CAM Metro and Cambourne Guided Busway technical issues

Cllr Thomas Bygott, District Councillor for Girton, Dry Drayton & Madingley

29th May, 2020

GCP map of the Rifle Range route

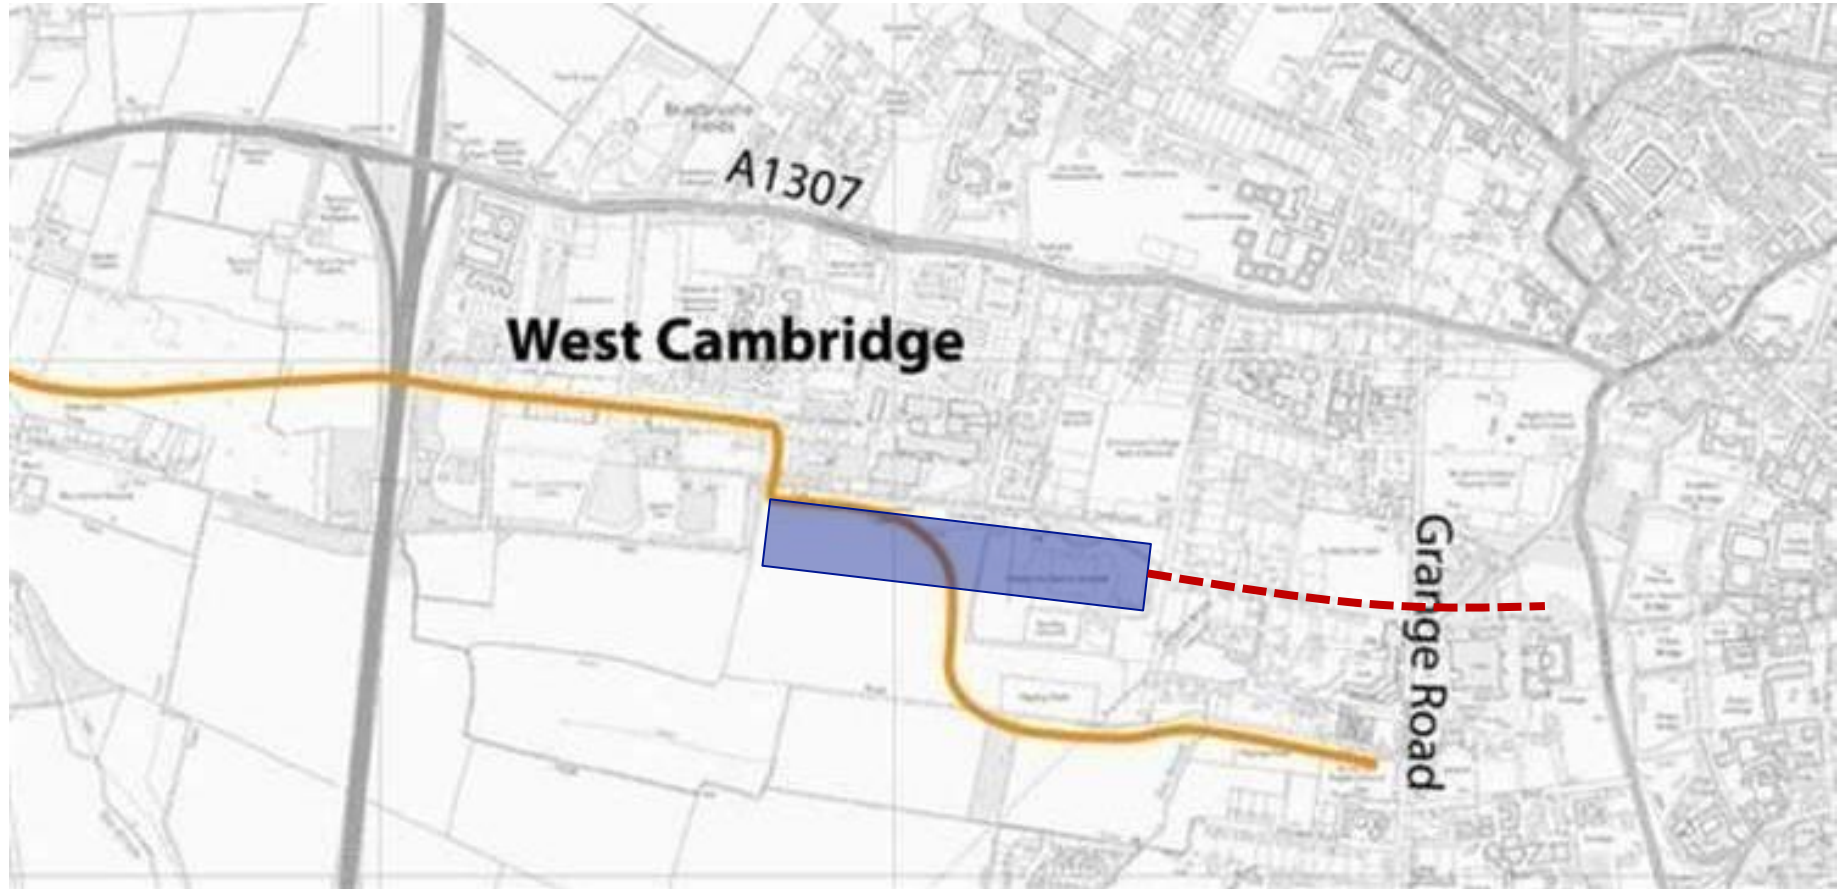
This route crosses over the best location to build a tunnel portal

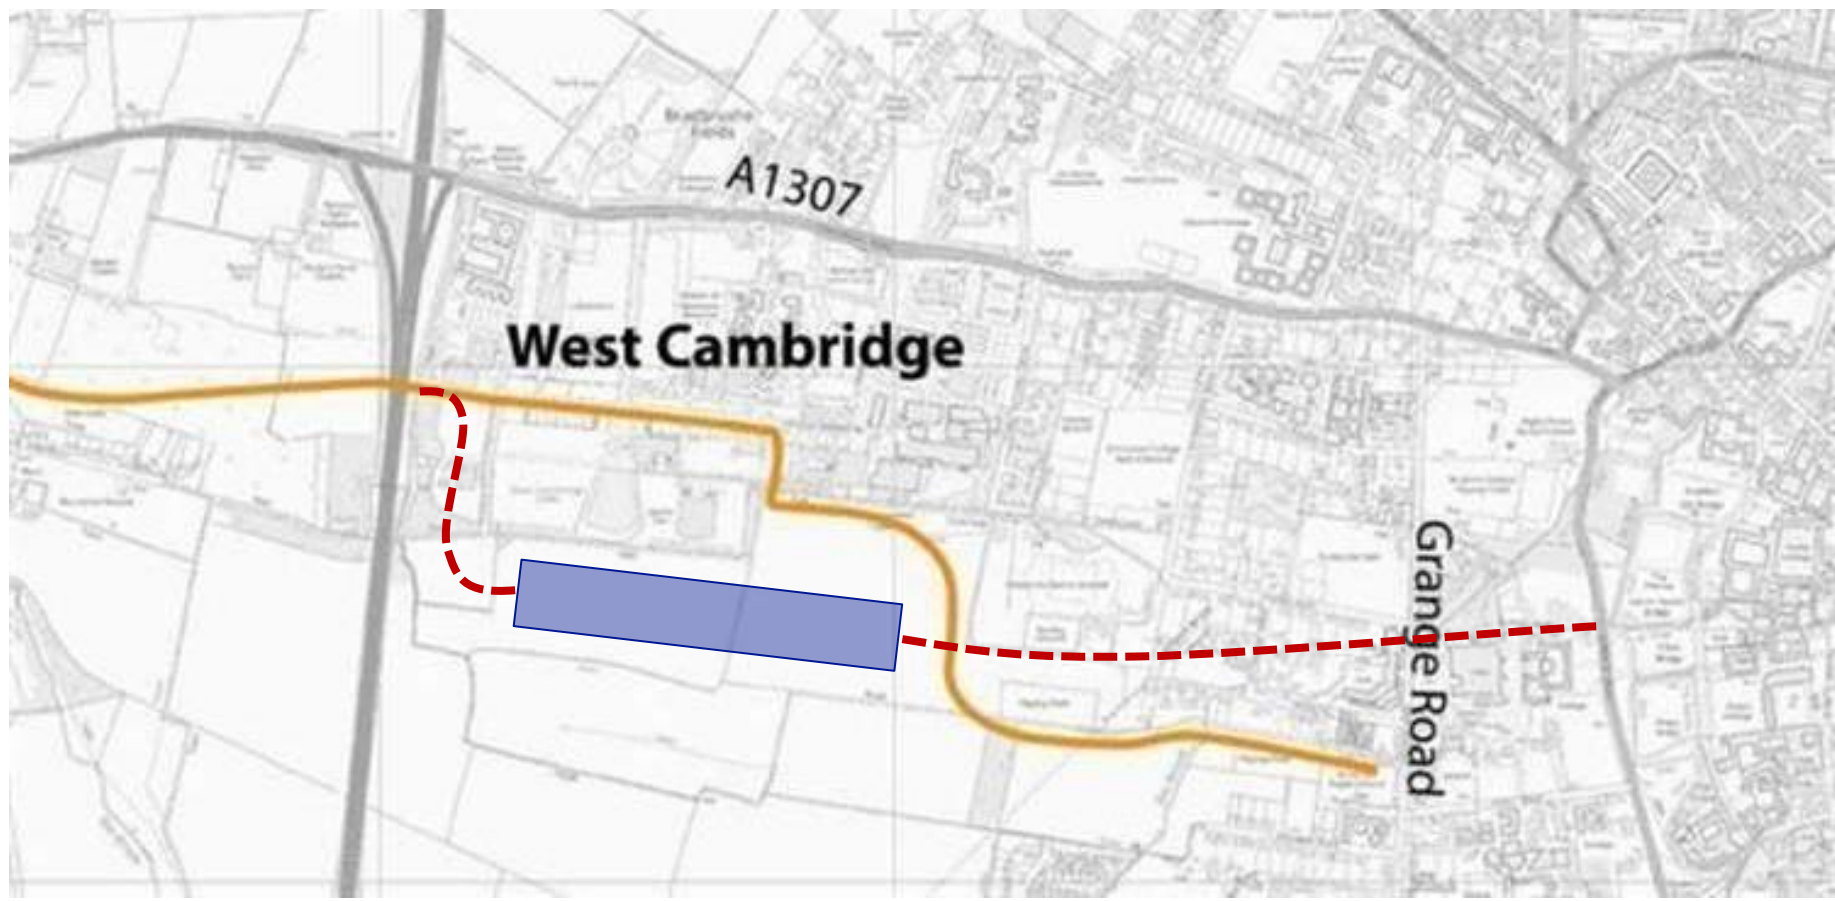
Moving the portal further south would result in both the station and the M11 bridge being in the wrong locations

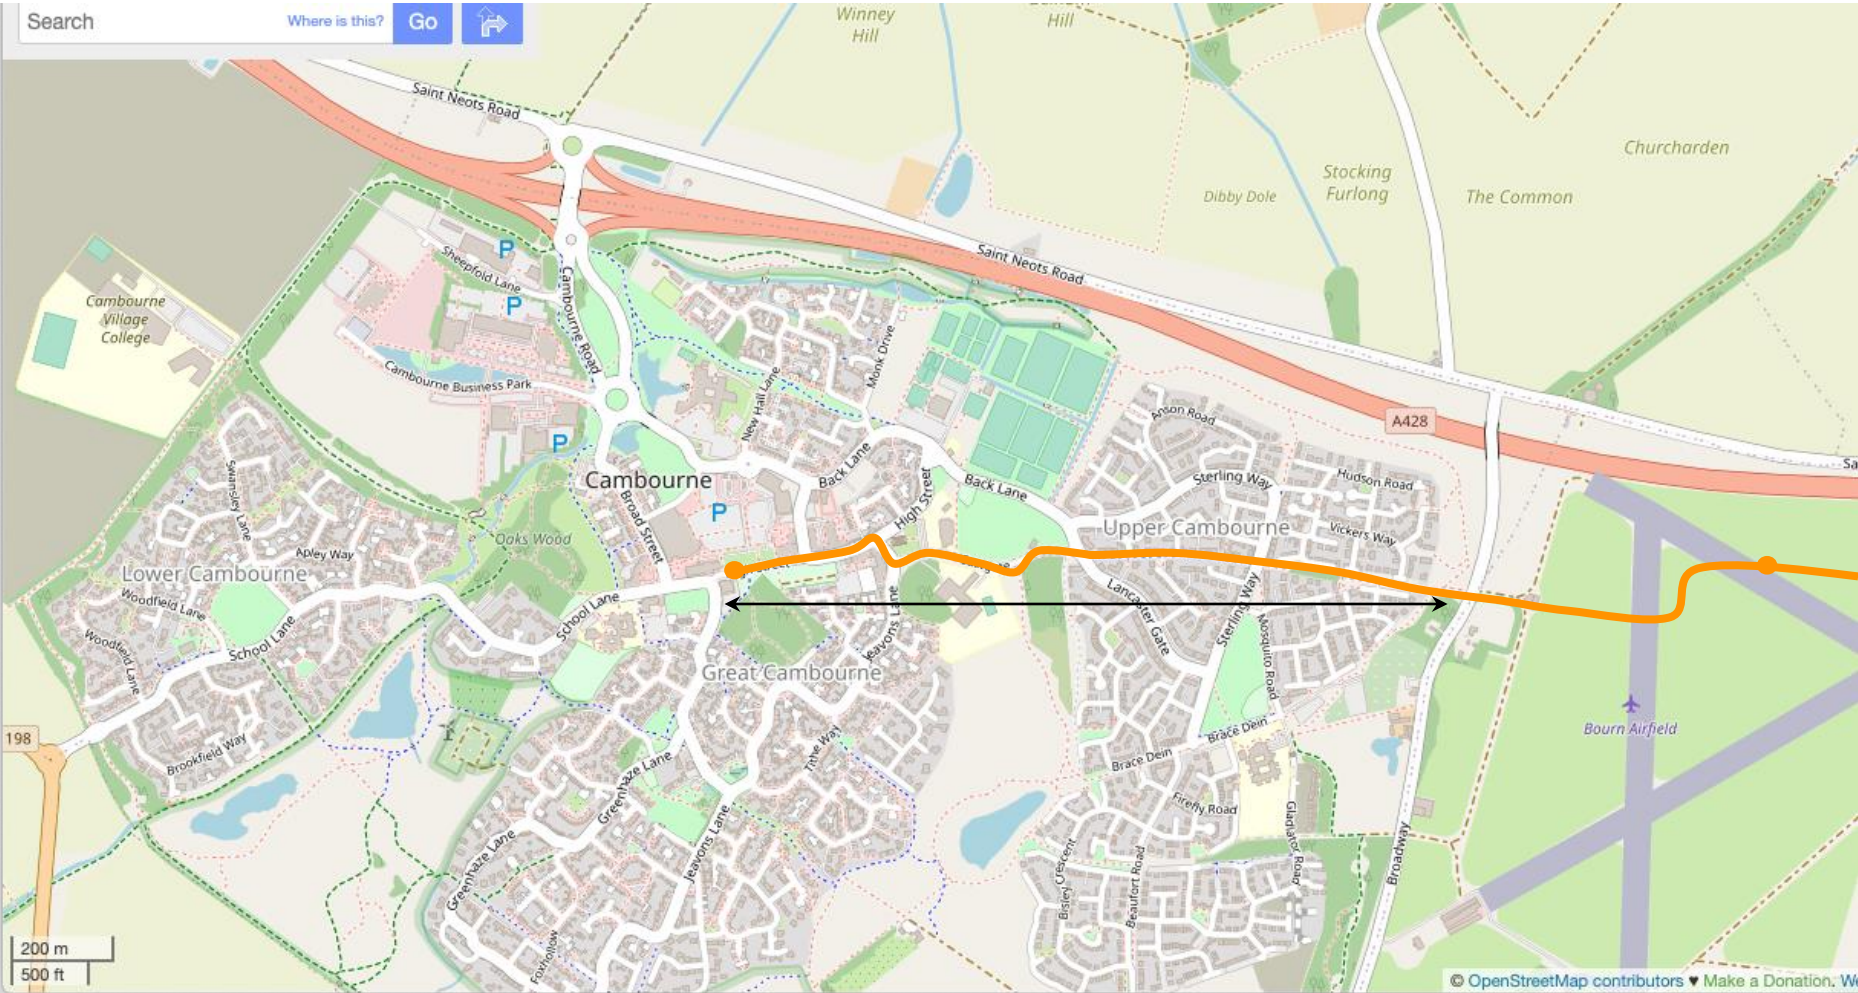
This section of the route wouldn't be suitable for automated vehicles

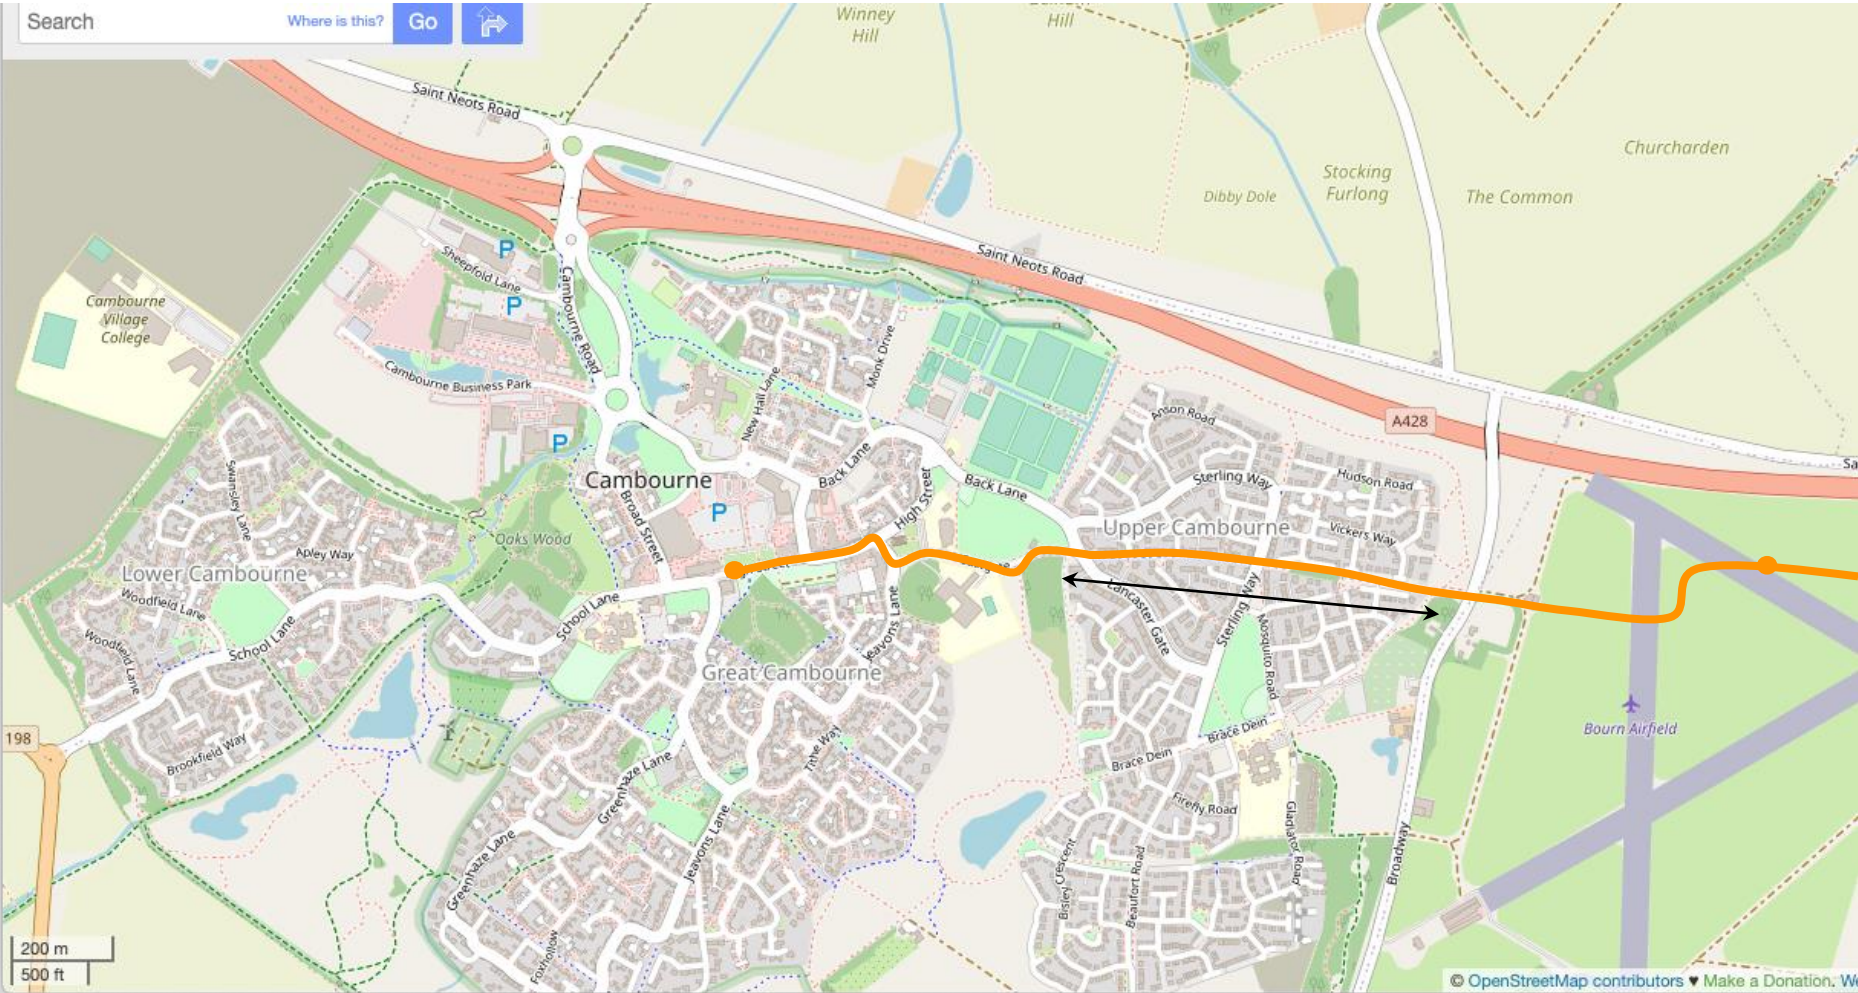
This section of the route contains numerous front doorways that face directly onto and within 2m of the route

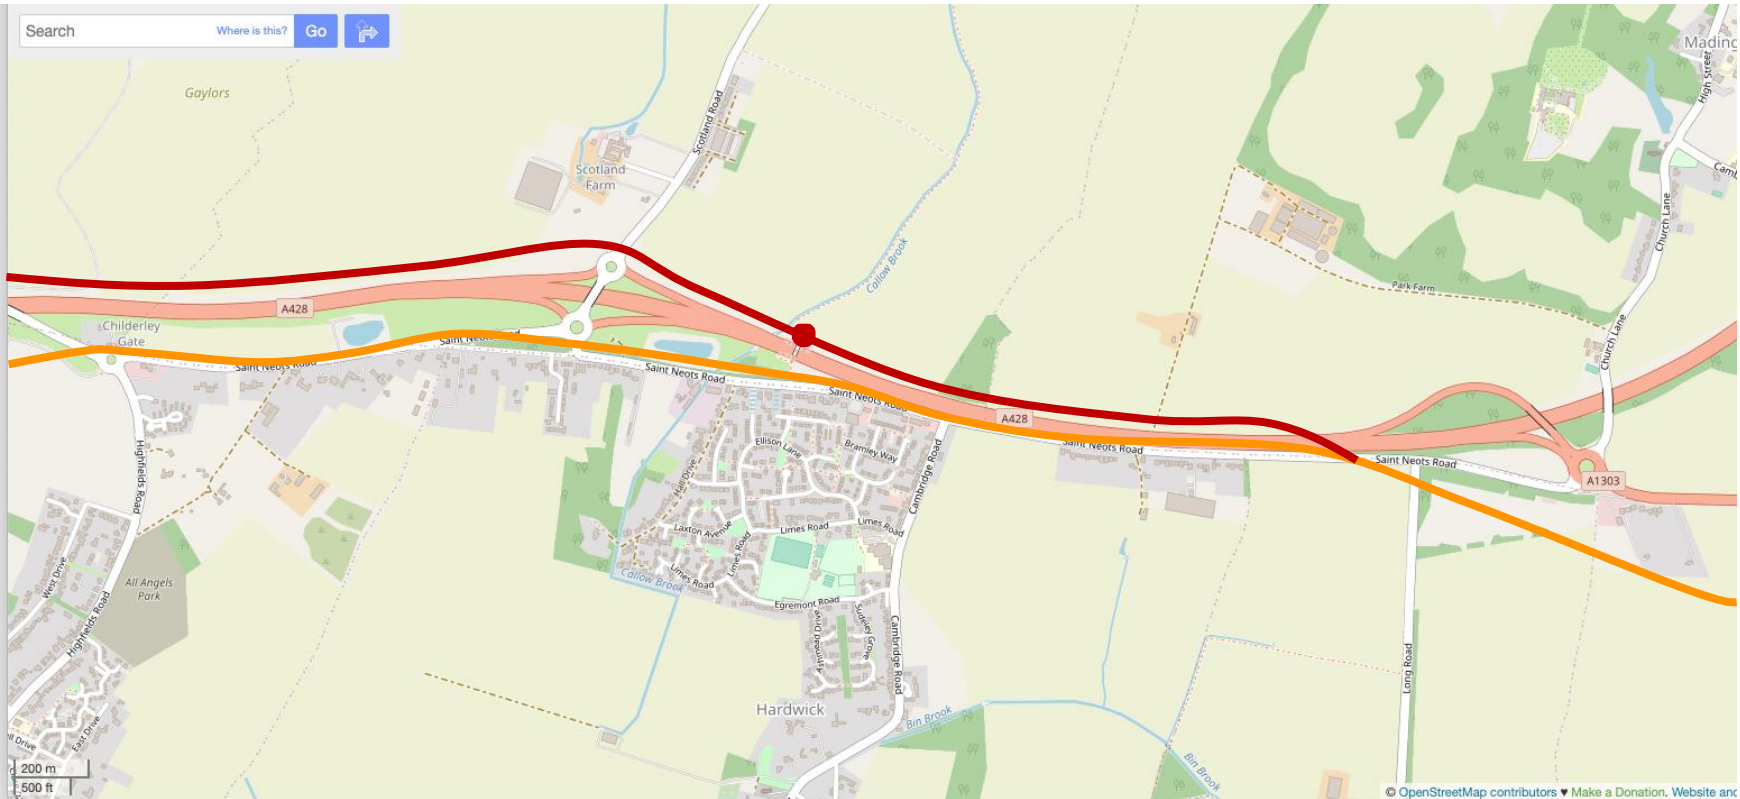
There are fewer obstacles along the north side of the A428.

A route north of the A428, with a Hardwick station at the existing pedestrian bridge, would enable an easier route for the Metro past Cambourne to St Neots. It would save the trees along St Neots Road and could be landscaped in a much more environmentally friendly way.
